Complementary Transmitter and Receiver Jitter Test Methodology

IEEE 802.3bm

CAUI AdHoc

April 5, 2014

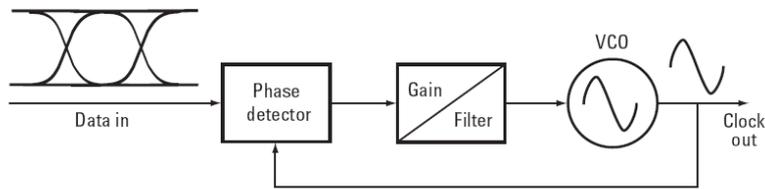
802.3aq (LRM) receiver jitter tolerance introduced an inconsistent set of specifications by separating stress receiver testing and transmitter jitter tracking

- Transmitter jitter relief through MJS Golden PLL was maintained
 - Compliant transmitters may have low frequency jitter present, but not observed due to by the Golden PLL tracking effect
- Receivers currently tested at two spot frequencies without additional stress
- Full stress with the addition of SJ can result in broken links that is not observed with stress and SJ imposed in independent tests
- Testing the receiver at only two discrete frequencies may not guarantee the receiver can actually tolerate transmitters with jitter tracked “masked” out by the Golden PLL
- Transmitter tracked “masked” jitter actually propagates through the link and could break CAUI-4 host receiver!

Receiver test should complement transmitter test

Reliable link operation requires that the receiver test complements transmitter test. The receiver test should be extended to include SJ as allowed in the current transmitter spec. Alternatively, the transmitter test could be more stringent, but it is not practical to force the transmitter to produce low or no jitter over regions where the receiver is not tested

Receiver Must Tolerate all Jitter Components Propagating Down the Link

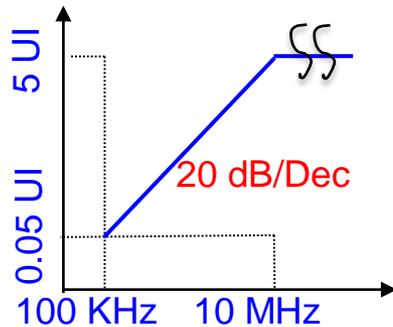
Testing at just two frequencies is not an option if there is potential interoperability issues!

Major Inconsistency!
CDR may not be able to track a Compliant CMU Output
